Access Compliance Report

Public Rights-of-Way

(Curb Ramps)

Intersection ID: 13019	Main Street: E_STONEWALL_ST	Cross Street: S_BREVARD_ST	Location: NW
ADA ID: 446784057200	Ramp Type: Perp	Initial Pass/Fail: Pass	Overall Compliance: No
		Severity Score: 7.75

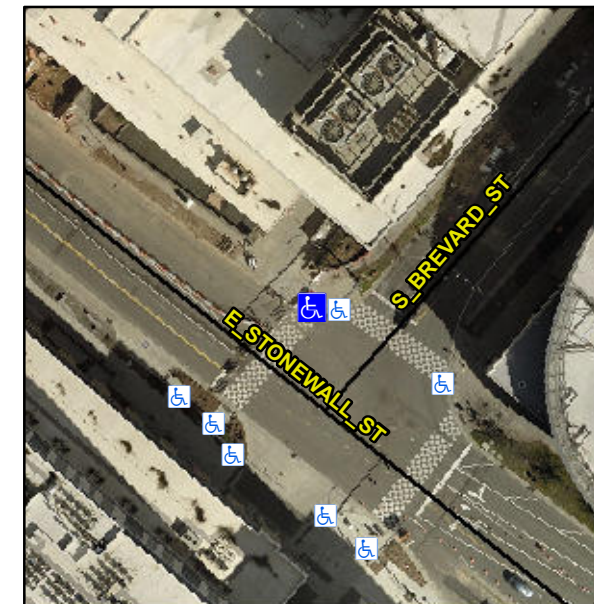
Not Found, R304.5.3, R302.7.2

Compliance	Description	Data	Compliance	Description	Data
N/A	Ramp Length (in)	85.0	Yes	Ramp Slope (%)	0.8
Yes	Ramp Width (in)	64.0	No	Ramp XSlope (%)	3.4
N/A	Flare Type LT	Sloped	N/A	Flare Type RT	N/A
N/A	Flare Slope LT (%)	3.6	Yes	Flare Slope RT (%)	9.8
N/A	Flare Traversable LT?	Yes	N/A	Flare Traversable RT?	Yes
Yes	Landing Length (in)	60.0	Yes	DWS Provided?	Yes
Yes	Landing Width (in)	60.0	Yes	DWS Contrast?	Yes
Yes	Landing Slope (%)	0.2	Yes	DWS Length (in)	25.0
No	Landing X Slope (%)	6.0	Yes	DWS Full Width?	Yes
N/A	Landing Curb? (Y/N)	Yes	Yes	DWS Offset (in)	0.0
N/A	Shared Landing?	No			
Yes	Gutter Ponding?	No	Yes	Gutter Slope (%)	0.3
No	Gutter Lip Ht (in)	0.5	No	Gutter X Slope (%)	2.4
N/A	Painted X Walk1?	Yes	N/A	Painted X Walk2?	N/A
	X Walk 1 Direction	To SW		X Walk 2 Direction	N/A
N/A	X Walk 1 Width (in)	144.0	N/A	X Walk 2 Width (in)	N/A
	X Walk 1 Slope (%)	2.4		X Walk 2 Slope (%)	N/A
	X Walk 1 X Slope (%)	2.0		X Walk 2 X Slope (%)	N/A

**Remove & Replace Entire Ramp.
Remove & Replace Gutter.**
